WB/10/0852/OUT
CEN
JA

Location : Teville Gate Worthing

Proposal: Outline application for the demolition of existing buildings and erection of a mixed use development comprising multi screen cinema, restaurants and cafes, foodstore, hotel, health and fitness centre, offices, multi-function conference and exhibition centre, two residential towers containing 229 apartments together with 19 apartments on a new residential frontage to Teville Road and 12 apartments on a new residential frontage to Broadwater Road, 967 car parking spaces together with a new partially covered pedestrian arcade, landscaping and urban realm and access arrangements

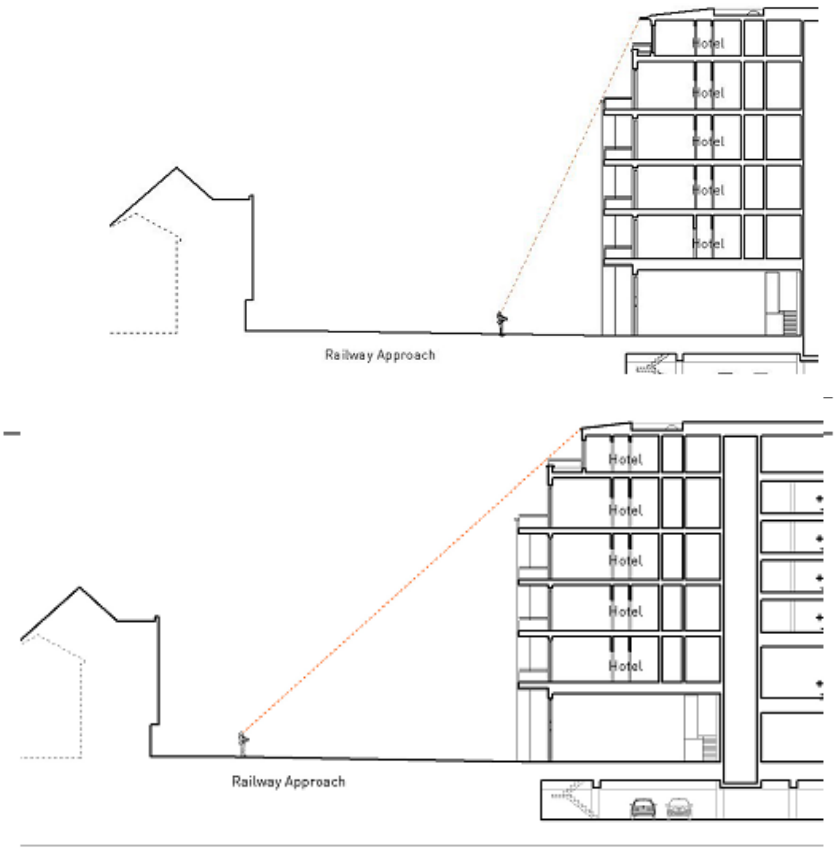
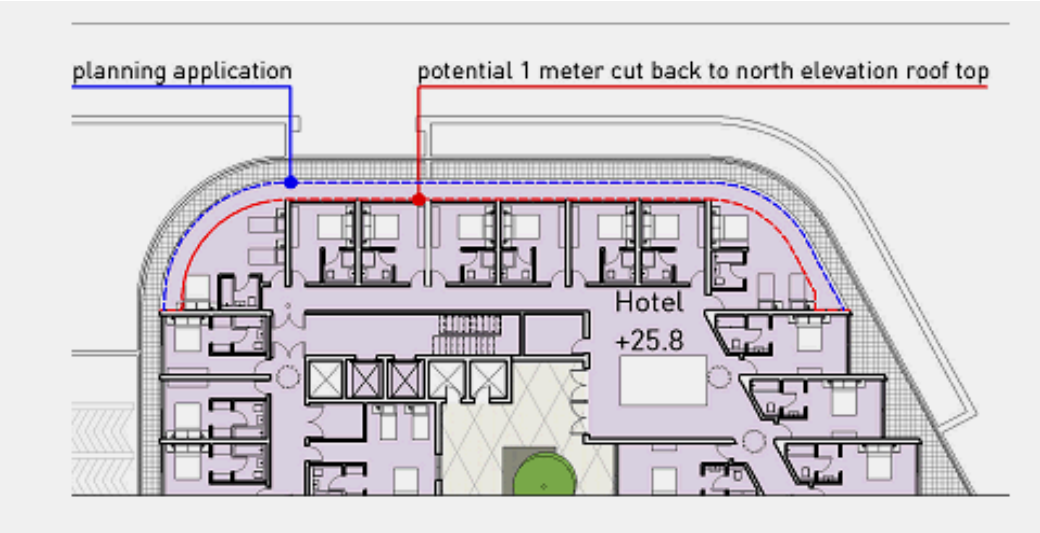
In response to a request from WBC, RDA have considered the possibility of further setting back the top floor of the hotel, in order to reduce even more its already limited visibility.

Figure 12 demonstrates how a further 1.0 m setback is feasible in layout terms. It is likely that with the removal of the overhanging roof/brise soliel

detail to high level eaves, in addition to such a set back the top floor of the building would not be visible from ground level within Railway Approach.

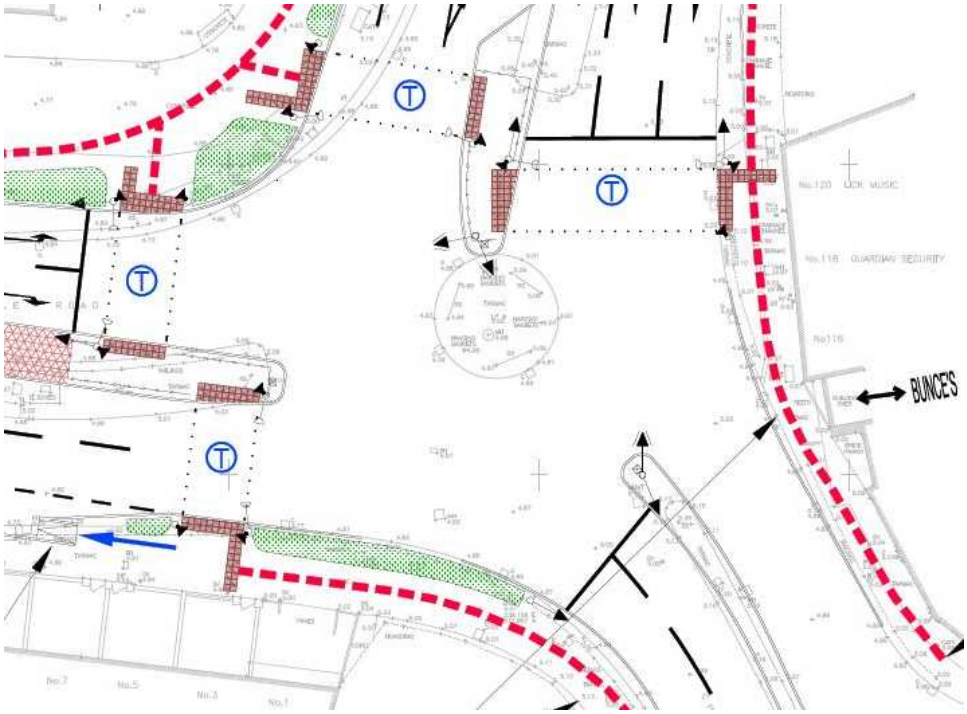
The preferred solution by the Highway Authority removes the previous straight crossings and ‘all red phase’ to allow all pedestrians to cross at the same time and replaces this with a more conventional solution with staggered pedestrian crossing points. This enables the signals to operate more effectively to ease congestion at these junctions particularly during peak hours. The revised approach for the Teville Road junction is indicated in the following extract from the revised plans:

Whilst it is inevitable that the development would increase congestion at these junctions the highway Authority is satisfied that these junctions would operate satisfactorily and improve safety for all modes of transport. The one exception is the impact of development traffic on Teville Road as set out in the Highway Authorities Consultation response.
